1. Procedure Number FNP-O-EIP-8 Revision Number 19
 Procedure Title NOTIFICATION ROSTER

FARLEY NUCLEAR PLANT
NUCLEAR SAFETY EVALUATION CHECK LIST

1. Procedure Number FNP-0-EIP-4 Revision Number 5
 Procedure Title CHEMISTRY & HEALTH PHYSICS SUPPORT TO THE EMERGENCY PLAN

Gamma Dose Rate in Containment versus Time After Shutdown

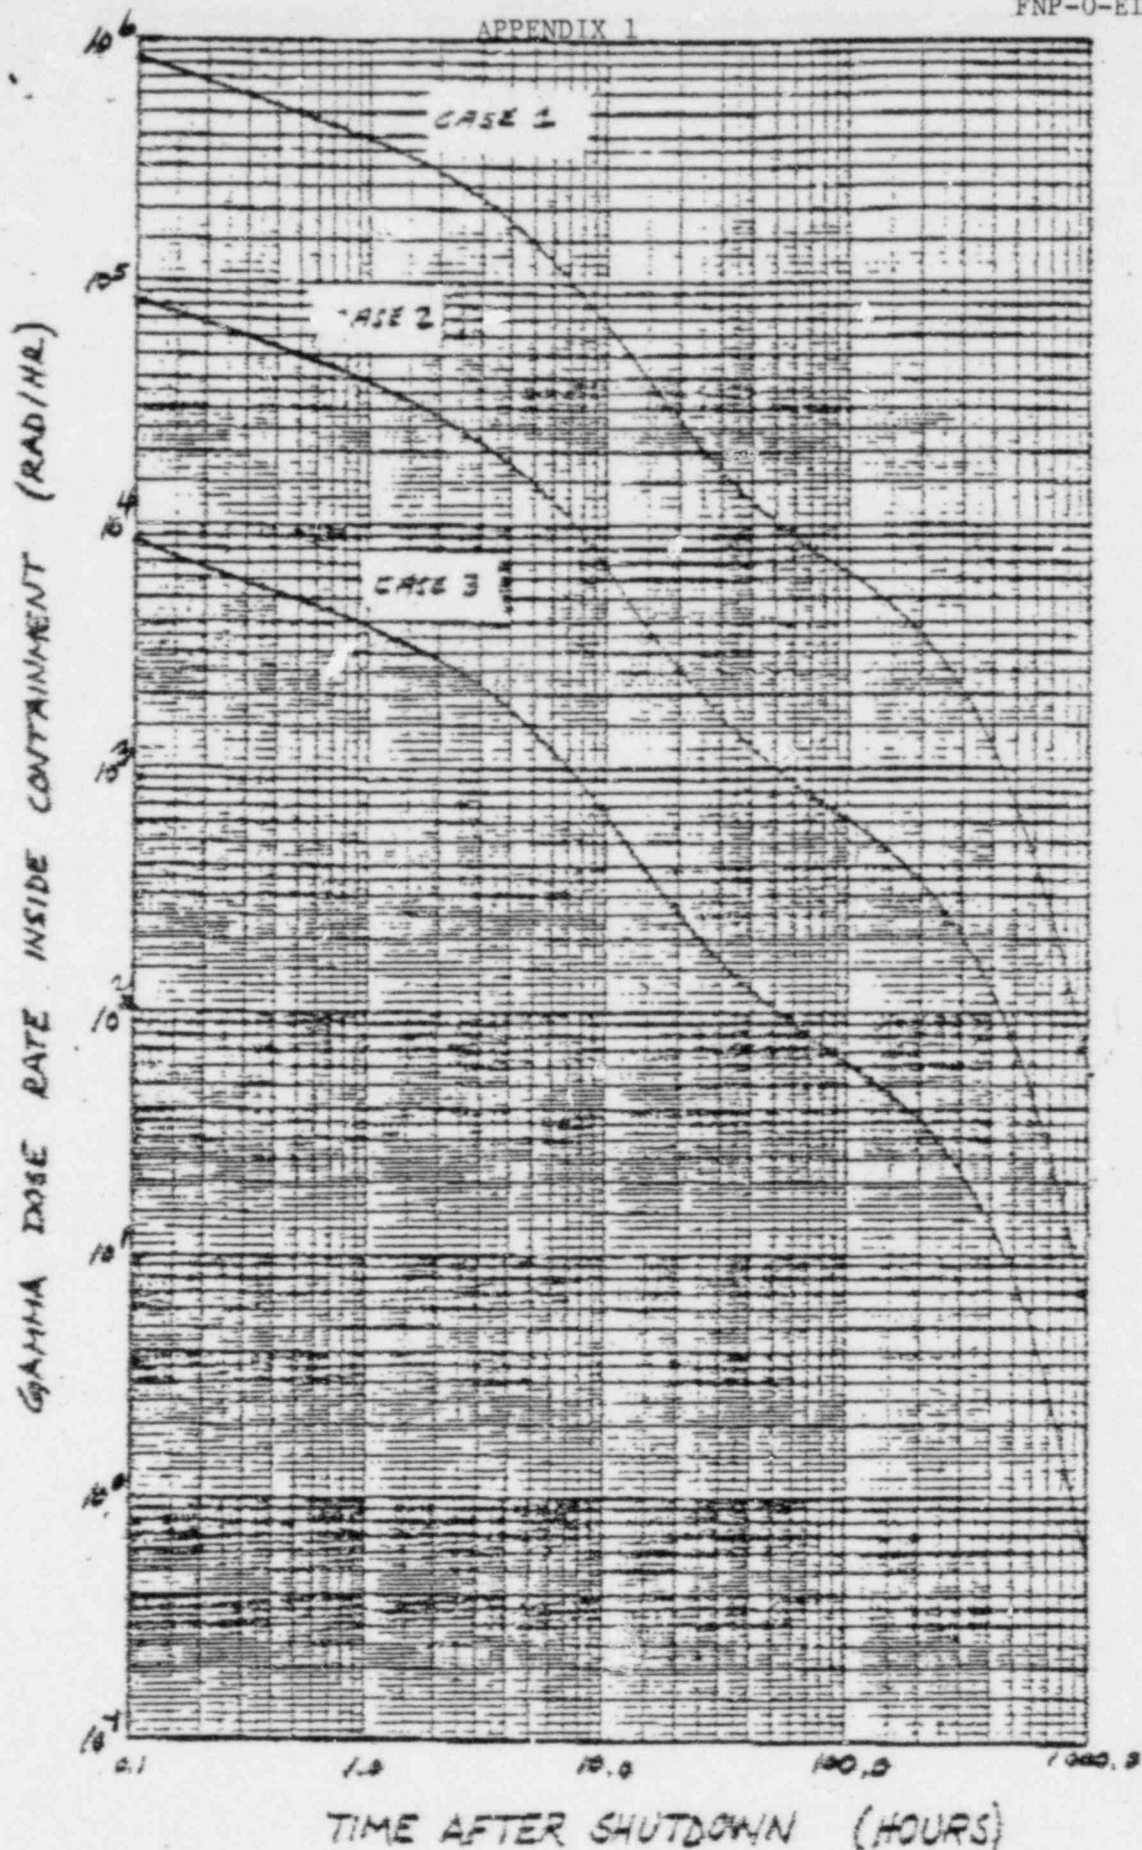
Added methodology to assess core damage based on dose rate inside containment

The graph on sheet 3 of this PCN shows gamma dose rates inside containment as a function of time after reactor shutdown. The three cases shown on the graph represent the following:

CASE 1: 100% Core Melt. (100% of noble gas and 25% of iodine core inventory is released into the containment and is available for leakage to the environment.)

CASE 2: 10% Core melt. (approximates total cladding failure with 10% of noble gas and 2.5% of iodine core inventory released.)

CASE 3: 1.0% Core Melt or 10% Cladding Failure. (1.0% of noble gases and 0.25% of iodine core inventory released.)

Note that these plots are for volumes above the operating deck EL. 155'-0". All assumptions made to plot the graph are the same as those given in the FSAR for LOCA analysis.

[One of these assumptions is one train of CMT. Spray & one train of CMT. coolers is operating. Two trains of CMT. Spray were considered in a separate analysis. Assuming both trains are operating would effectively double the removal rate of the elemental & particulate forms of iodine. However, due to the limit of spray removal credit allowed by the NRC (DF=100), the sprays would be "cut-off" in half the time. This effect would be seen in the first 30 minutes after shutdown, but is negligible in the graph due to the presence of noble gases. Thus, justification of using the FSAR LOCA analysis as guidelines for this analysis.]
